# **Commit Request 4p15\_3: Default of Clip Method to Slow**

Hansel D'Silva and Sam Kocsis  
Amphenol Corporation

IEEE 802.3 Channel Operating Margin (COM) Open Source Project Ad Hoc

# Purpose for Commit Request

# Fast vs. Slow Clip Method: Results on Run Time

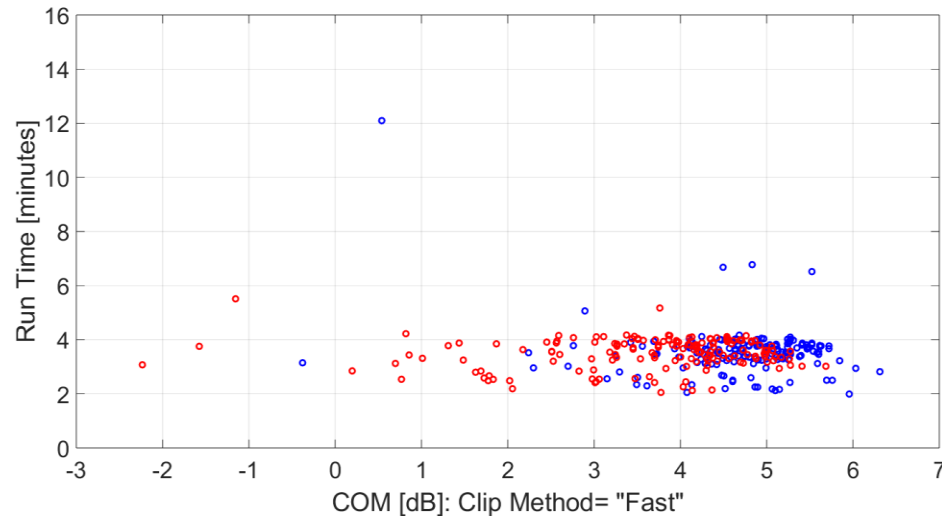
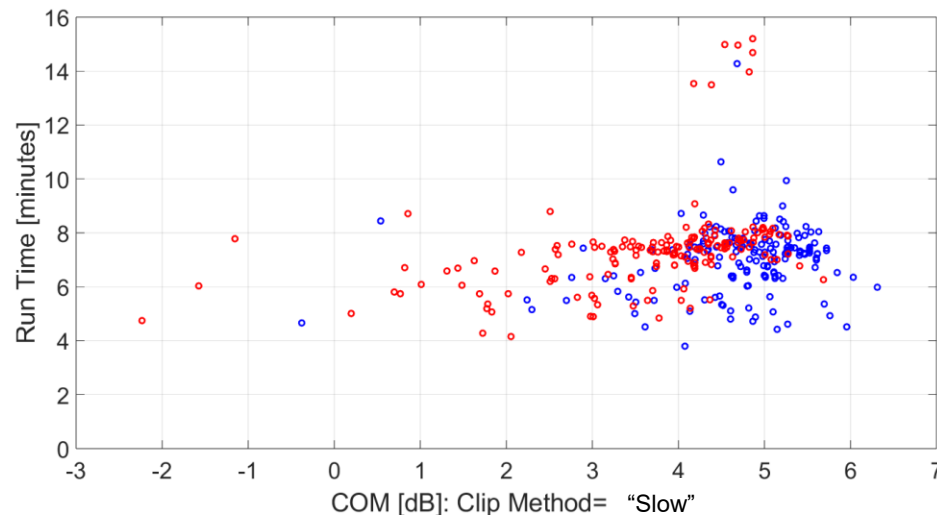
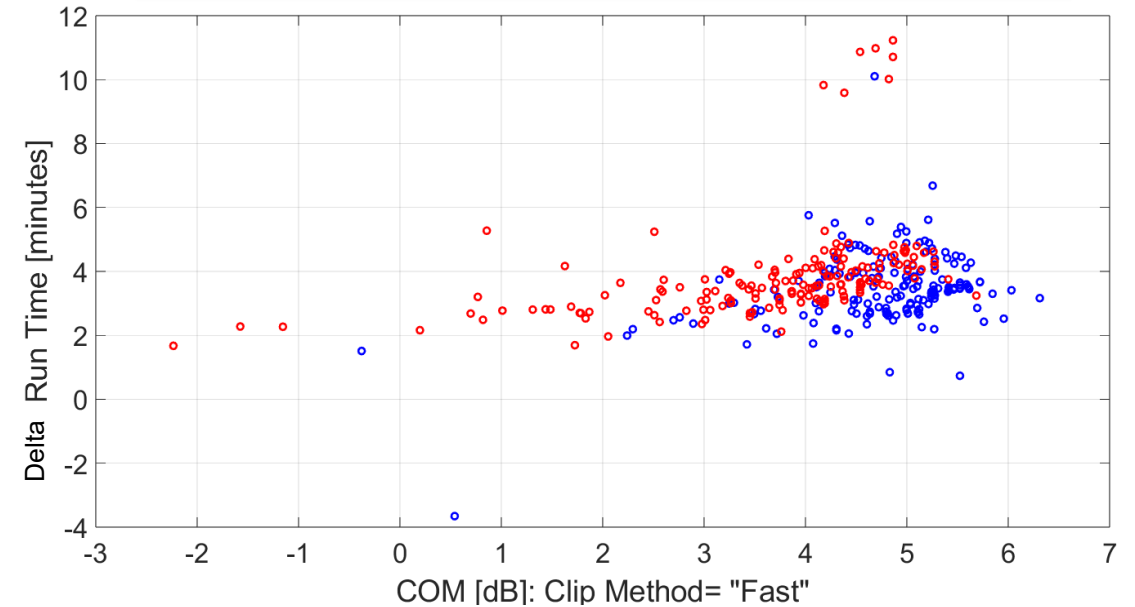
- Clip Method of "Slow" presents a much as 4x increase in the run time compared to Clip Method of "Fast".

# Fast vs. Slow Clip Method: Results on COM and Run Time

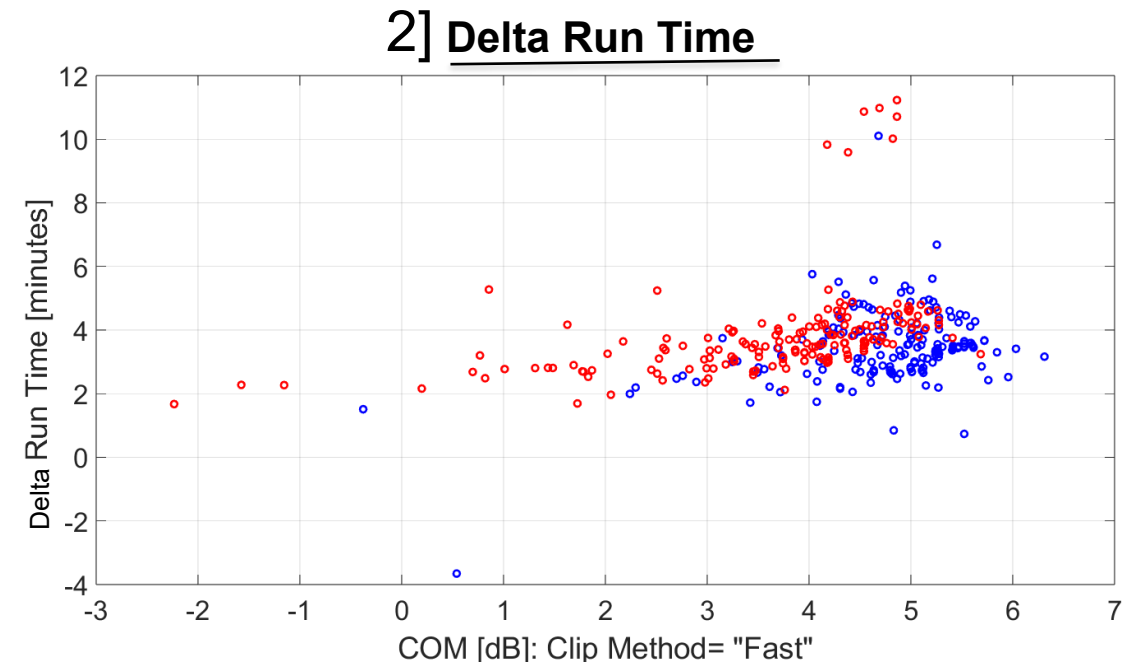
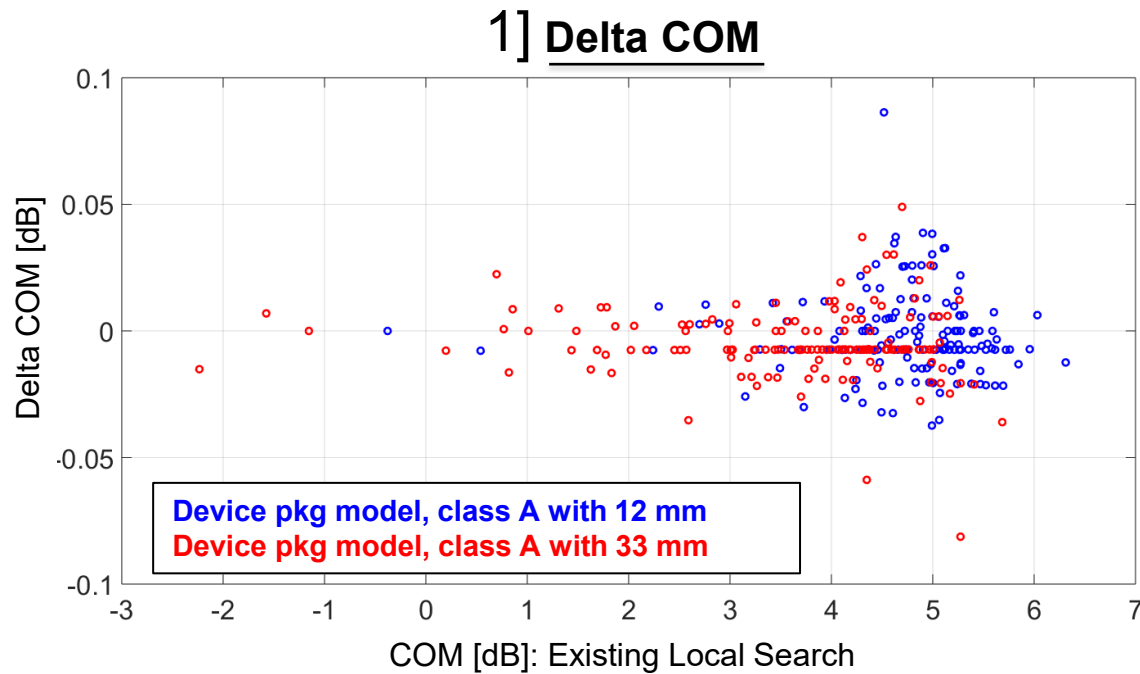
- Clip Method of "Slow" presents a negligible change in the value of COM when compared to Clip Method of "Fast".
- The observed delta COM of  $\pm 0.1$  dB was observed in [https://www.ieee802.org/3/ad\\_hoc/COM/public/telecon/250617/shakiba\\_COM\\_01a\\_250617.pdf](https://www.ieee802.org/3/ad_hoc/COM/public/telecon/250617/shakiba_COM_01a_250617.pdf)
